Technical Bulletin

Bulletin No.: PRO-03-17 Effective Date: 2/15/79 Page: 1 of 1

Subject: **VM-2 Piece No. 289253**

MV-2 289253

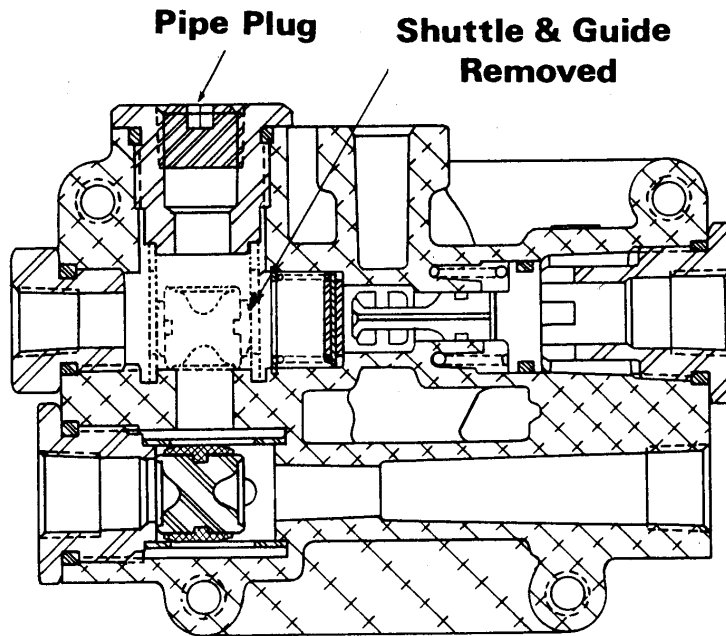
VM-2 Piece No. 289253 omits the double check valve shuttle and guide which normally receives the TC-2 signal. (The omitted portions are shown dotted in cross-section Figure 1.) The port in the cap nut is plugged. If 289253 is replaced in service with a standard VM-2, such as 288605, and a pipe plug is placed in the TC-2 port, the service line may trap air causing the trailer brakes to drag and keep the stop lamp switch on.

For 289253 replacement, it is recommended that 289253 be used. However, if necessary, a standard VM-2 may be used if the double check shuttle and shuttle guide are removed and the trailer supply plugged.
